Appl. Serial No. 10/667,162
Resp. dated January 5, 2005
Reply to Office Action of Oct. 5, 2004

AMENDMENTS TO THE DRAWINGS

FIG. 4a

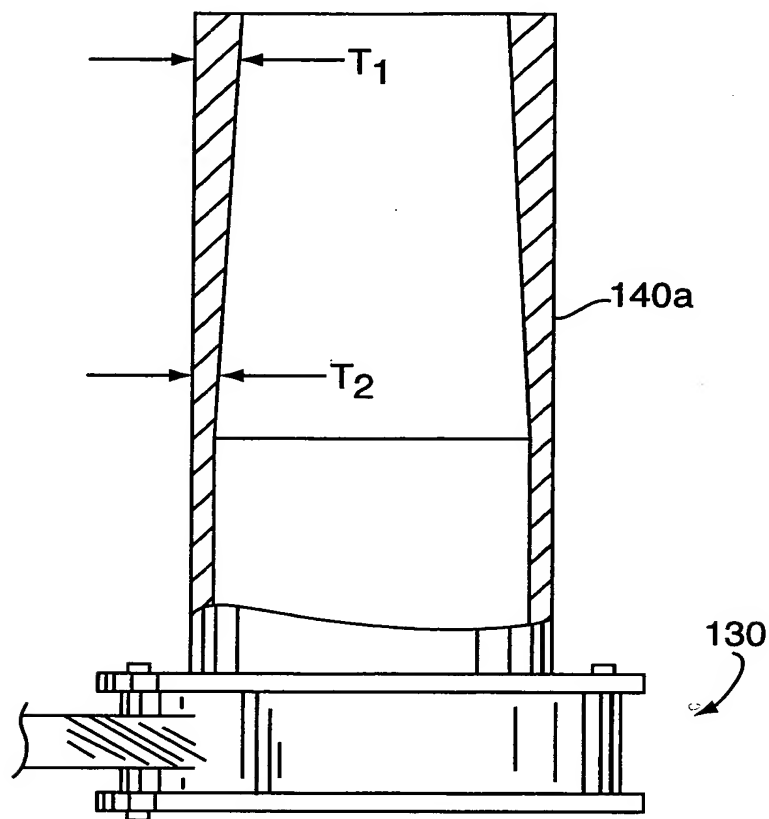
Please replace sheets 1/3 to 3/3 of the drawings with replacement sheets 1/4 to 4/4. New FIG. 4A has been added and is included in new sheet 4/4. New FIG. 4A shows an alternative embodiment of the chimney, 140a. Support for FIG. 4A can be found in paragraph [0061].
